Application for Licence Amendment

Licence Number	L8949/2016/1
Licence Holder	Bunbury Harvey Regional Council
File Number	DER2014/000052
Premises	Stanley Road Class II Putrescible Landfill Site 51 Stanley Road WELLESLEY WA 6233 Lot 45 on Deposited Plan 17161
Date of Report	19 December 2019
Status of Report	Final

Figure 12: Leachate generation model provided by Licence Holder

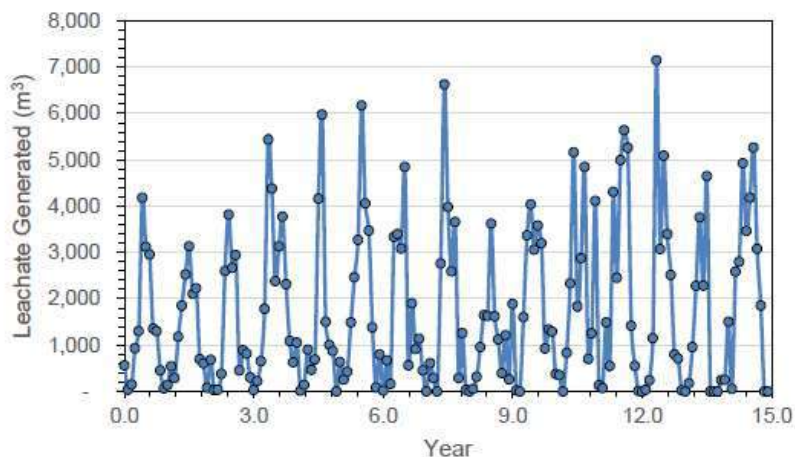
From the information provided within the application, DWER is unable to verify the calculations provided by the applicant and in particular there are uncertainties related to the assumptions used for the rainfall scenarios and it is unclear if uncontaminated stormwater will be directed away from the active landfill areas prior to waste filling to reduce the volume of leachate that may be generated during operations.

DWER notes that these assumptions may be overly conservative. DWER notes the figures representing leachate volumes generated (Figure 12) provided by the Licence Holder in the application show that on 4 occasions over a 15 year period the pond is expected to overtop.

should the Licence Holder wish to change the proposed design that a subsequent licence amendment application may be considered by DWER if supporting information is provided to describe all inputs and assumptions used for the basis for the design.

Figure 18: Proposed final capping layer

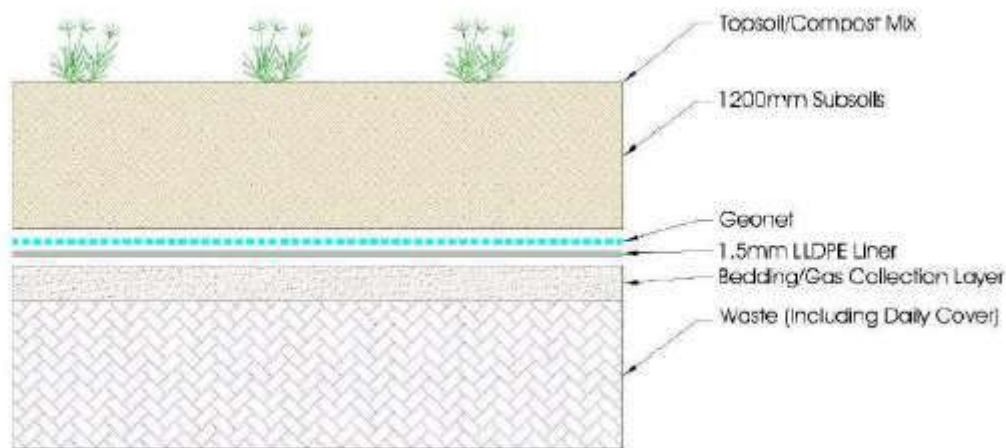
- Limited information has been provided to date in relation to managing the leachate pond freeboard.
- The Landfill Closure Plan provided in the application does not provide detail on the final capping design for cells 2/3 including how leachate generation rates in a post-operational environment will be controlled by the intended capping design.

The Licence Holder will be required to submit an updated Landfill Closure Plan outlining how landfill gas emissions will be controlled in closure of the landfill infrastructure.
